<b>Subject:</b>  NOISE COMING FROM UNDER THE DRIVER SEAT	<b>Bulletin No:</b> 09-026/13
	<b>Last Issued:</b> 10/09/2013

2013 CX-5 vehicles without power seats with VINs lower than JM3KE\*\*\*\*\*144861 (produced Aug. 24, 2012)

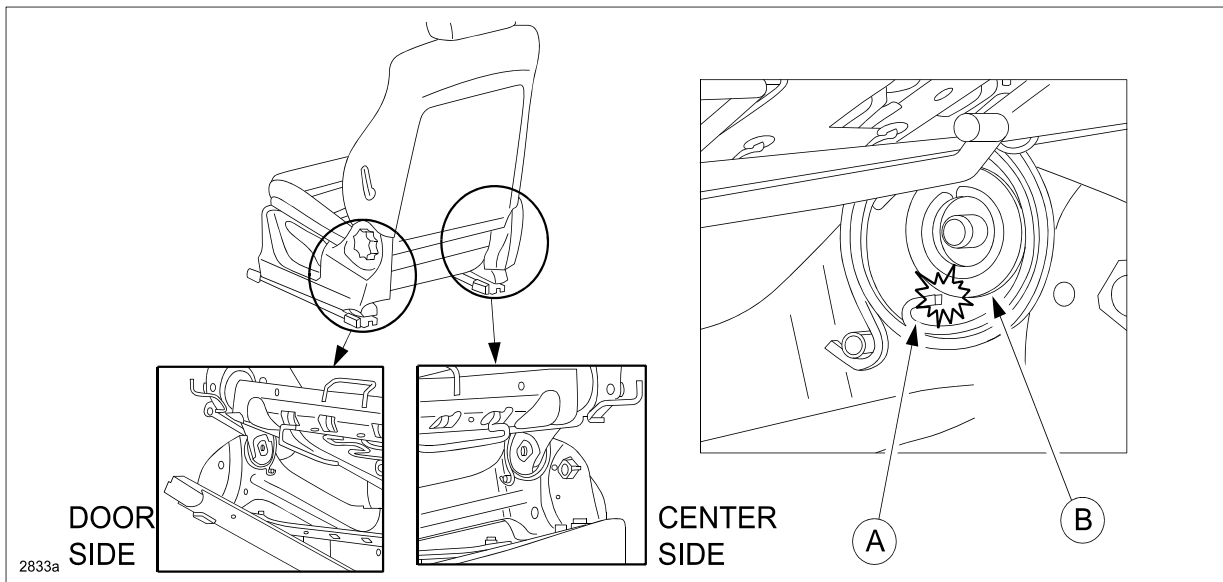
Some vehicles may exhibit a noise from under the driver seat while driving the vehicle. The noise may be caused by vibration when the bent-up end of the balance spring (A) interferes with the slider bushing (B).

To eliminate the noise, the clearance between the balance spring and the slider bushing has been increased. Customers having this concern should have their vehicle repaired using the following repair procedure.

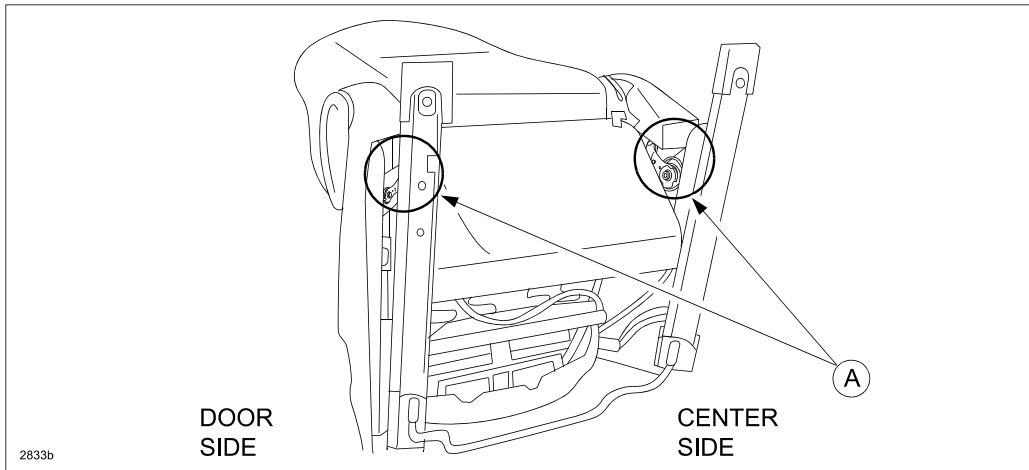
1. Verify that the noise is coming from the seat lifter area of the driver seat.
2. Set the driver seat lifter to the highest position.
3. Remove the driver seat according to the on-line instructions on MS3 or the Workshop Manual (section 09-13 FRONT SEAT REMOVAL/INSTALLATION).
4. Turn the seat upside down on a clean surface, then locate the grease points (A).

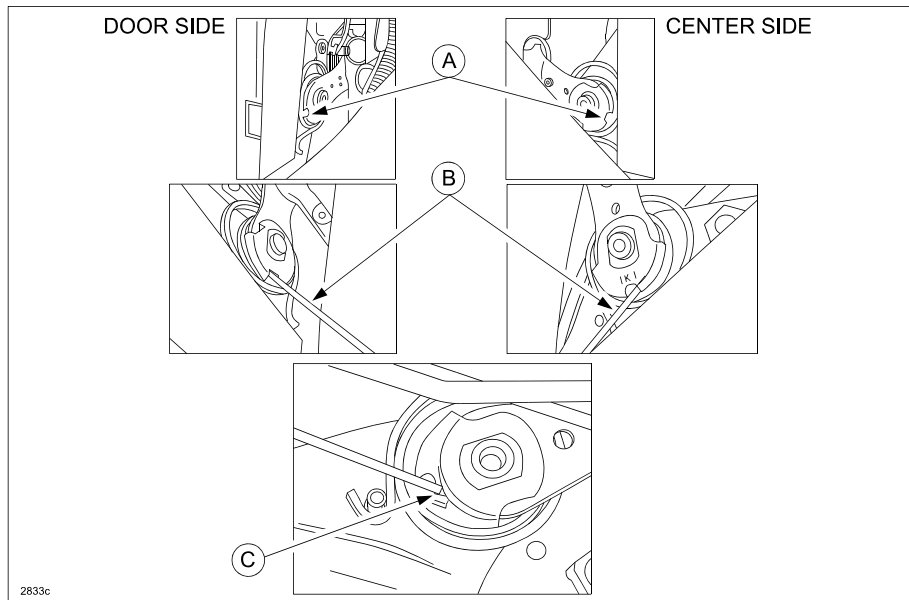
5. Locate the bracket holes (A). Insert the grease spray nozzle (B) into each bracket hole all the way inside until the nozzle touches the interference point (C).

6. Spray the grease for only (1) one second.

**NOTE:** If too much grease is sprayed, the excess will adhere between the balance spring plates and cause a new noise.
